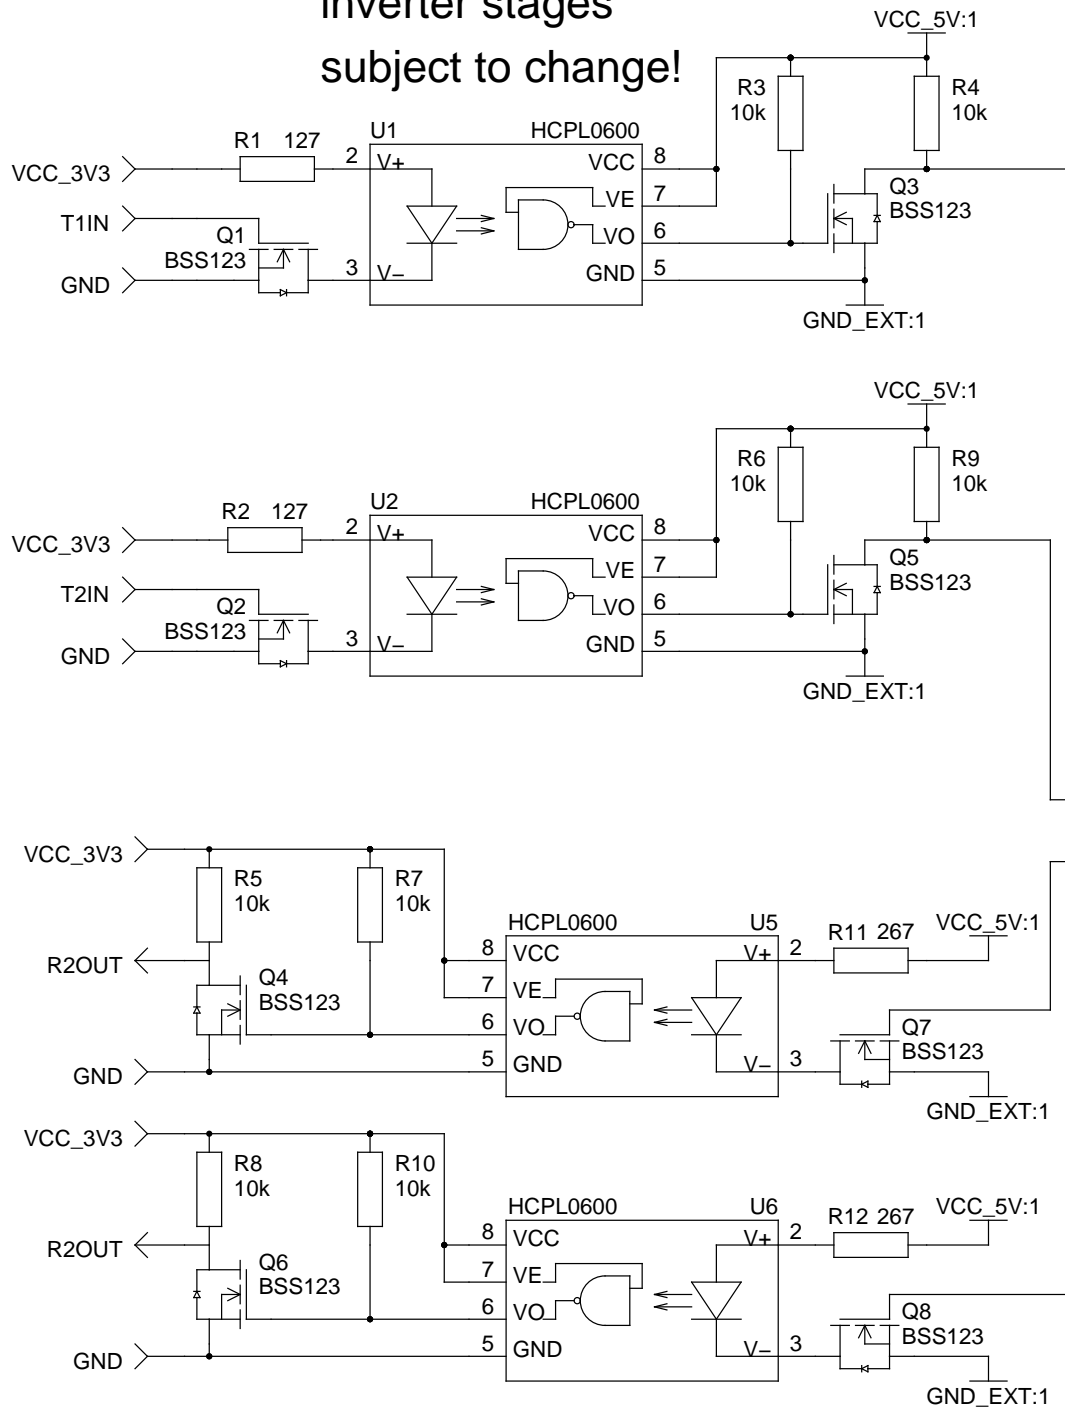
inverter stages subject to change!

verify MAX3232 circuit correct
when used at VCC of 5V
